Tanzila Textile Ltd.

Baroypara, Ashulia, Savar, Dhaka.
(24.017986, 90.243410)
12 April 2014

Observations

Structural Lateral Stability of Single Storey Industrial Building (Building 2)

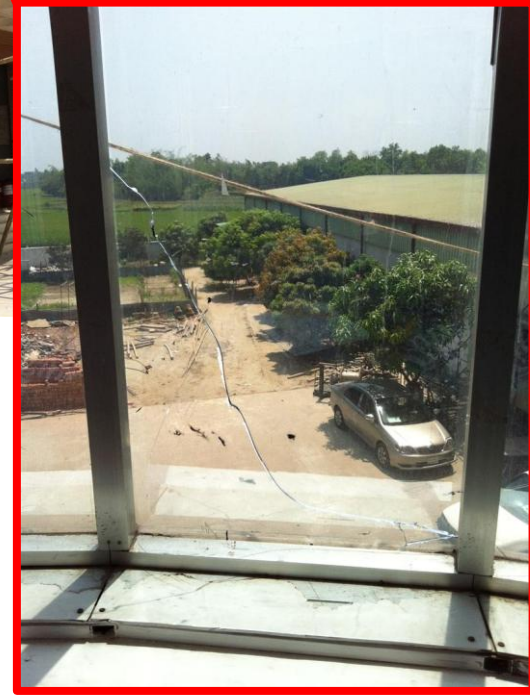
Building 2:
No in plane roof bracing observed.

Building stability appears to rely on RC columns and masonry infill perimeter walls cantilevering approx. 6.23m from the foundation. Foundation type is unknown.

Evidence of distress within masonry infill perimeter wall at interface with RC structure.

Unspecified aggregate in slabs

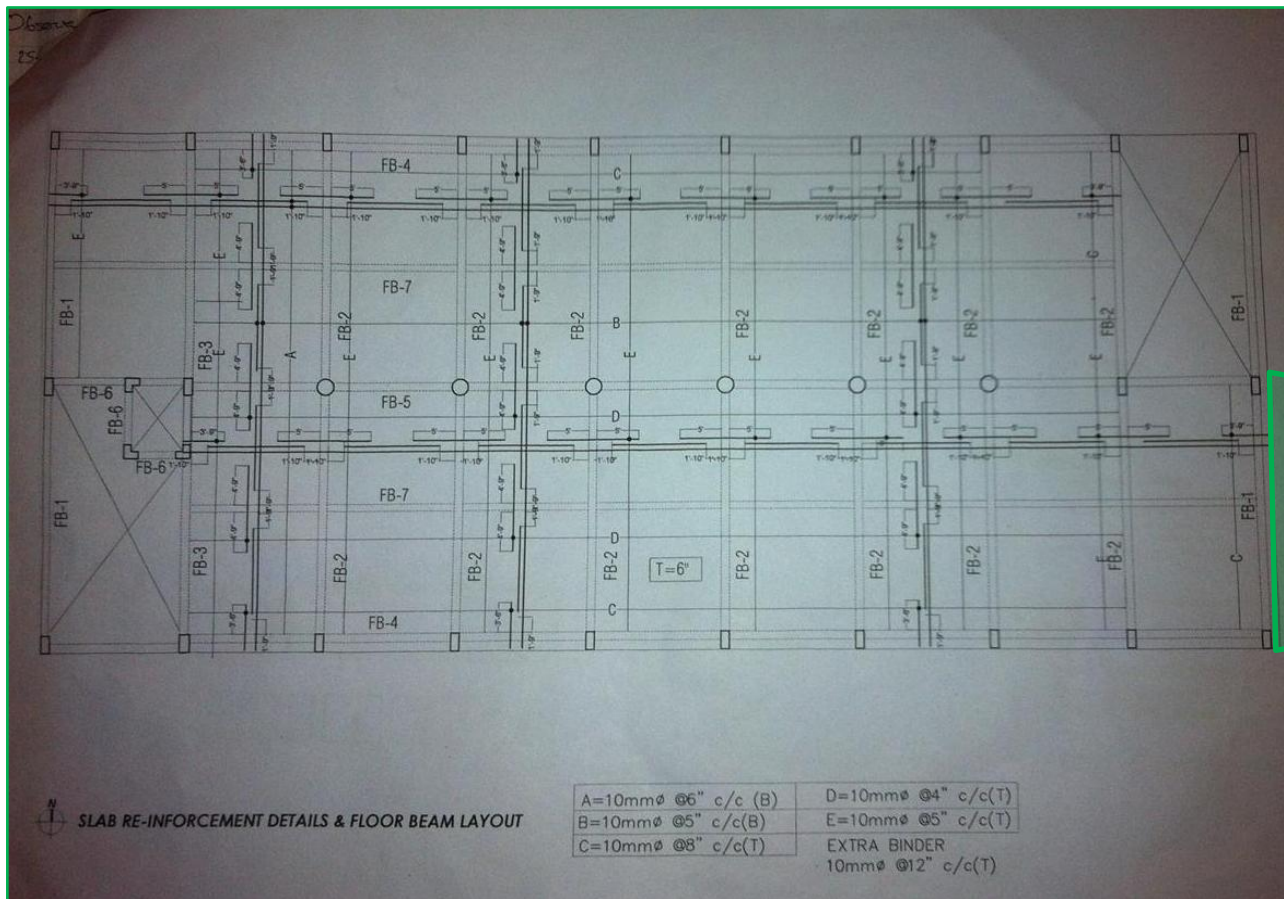
Structural design documents specify stone chip aggregate. Brick chip aggregate observed at a number of locations in the slab.

Not clear if brick chip aggregate concrete achieves minimum compressive strength required by design.

May be manifested as cracking and excessive deflection.

Undocumented Vertical Extension

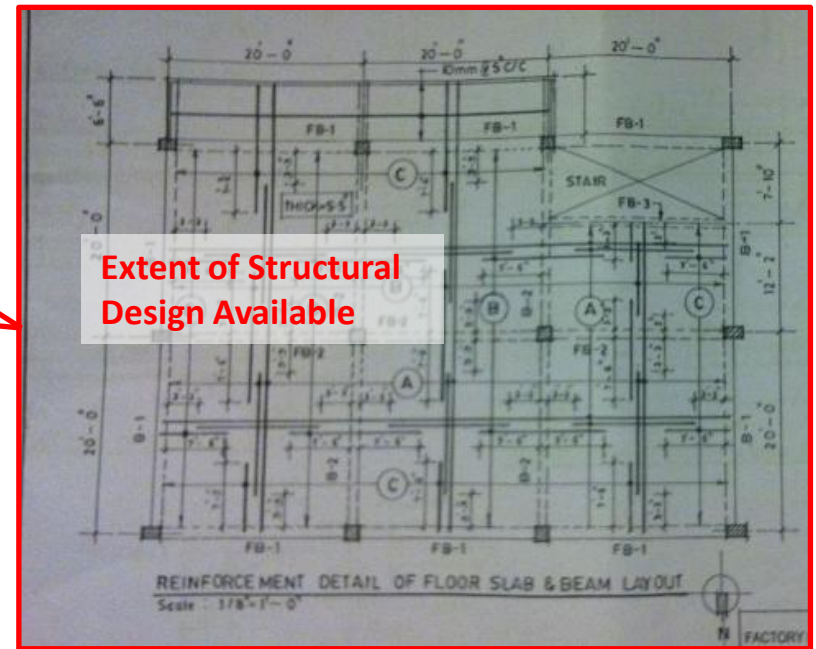
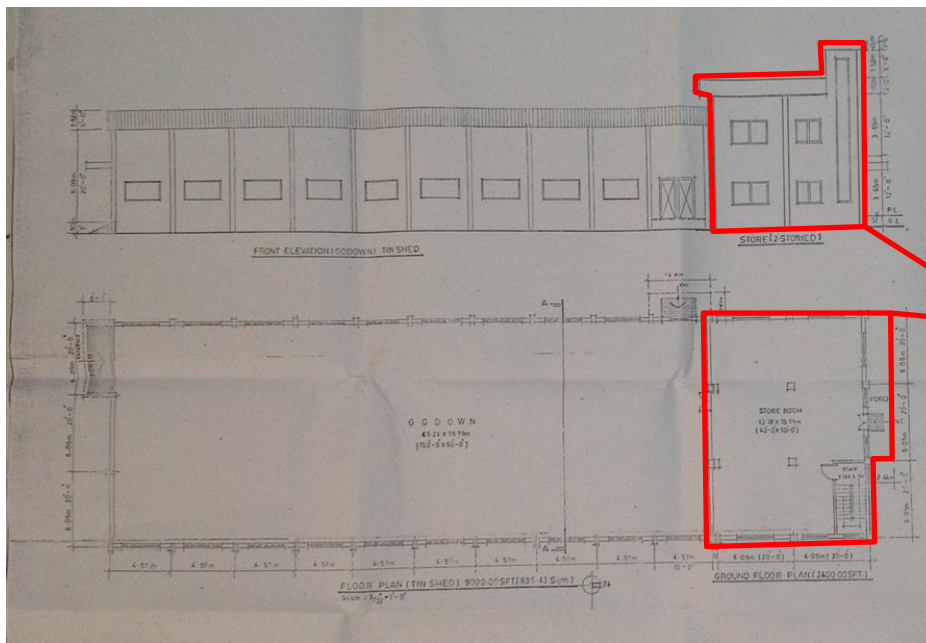
Cantilever on 4 floors not shown on structural drawings

Building 2

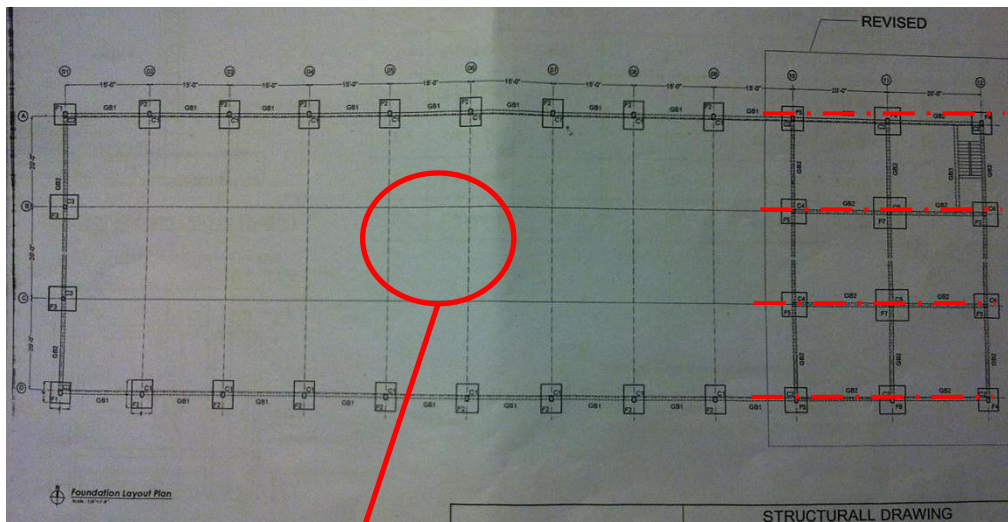
- Incorrect general arrangement for concrete structure (number of bays does not match construction).
- No relevant details for significant steel structure.
- No foundations detailed for central column to portal frame.
- Well graded stone specified, brick chip aggregate observed in slabs and columns.
- Stairs not constructed as per design drawings (position of landing beam).
- Toilet extension not recorded.

Undocumented and Non-engineered Ancillary Structures and Stairs

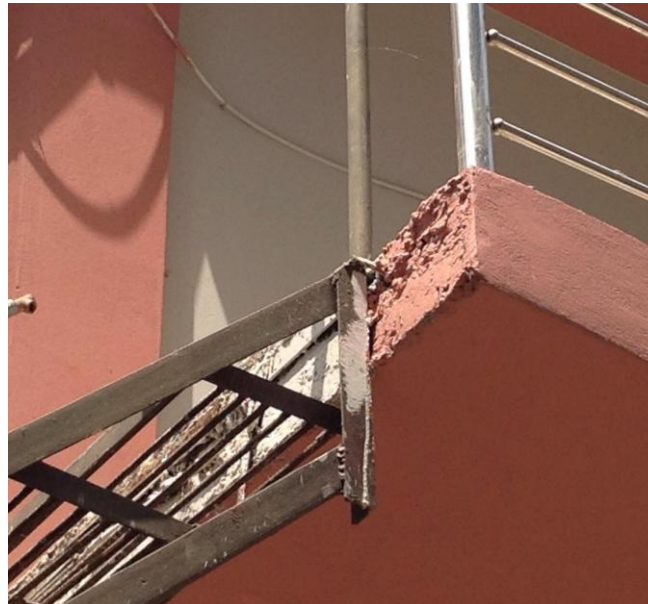
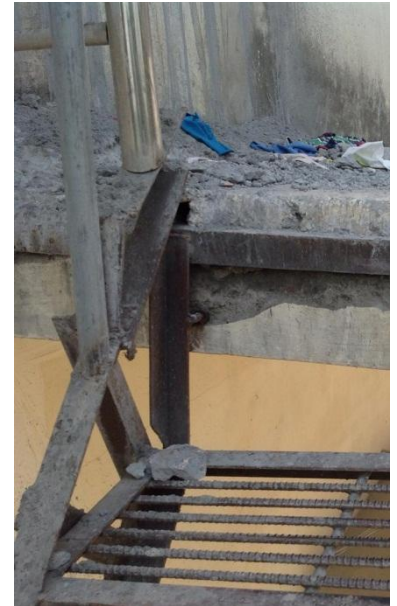
External steel stairs do not appear to be engineered.
Fixed to structure by tack welds to rebar.

Non-engineered external buildings used for a number of support functions. Some fixings to principal structures. Distress visible on a number of elements.

Item No.	Observation	Recommended Action Plan	Recommended Timeline
24	Undocumented and non-engineered structures and stairs	Prop all external steel escape stairs at steel stringer adjacent to connection to concrete landing. Building engineer to supervise propping immediately	Immediate - Now
25	Undocumented and non-engineered structures and stairs	Building Engineer to review escape stairs structural elements and all connection details for full access loads on stairs	6-weeks
26	Undocumented and non-engineered structures and stairs	Building engineer to design appropriate strengthening works as required	6-weeks
27	Undocumented and non-engineered structures and stairs	Factory manager to manage and co-ordinate any strengthening works with fire escape strategy for all areas	6-weeks
28	Undocumented and non-engineered structures and stairs	Factory Engineer to review single storey support buildings, taking account of loads applied to principal structures and advise on any strengthening works required.	6-weeks
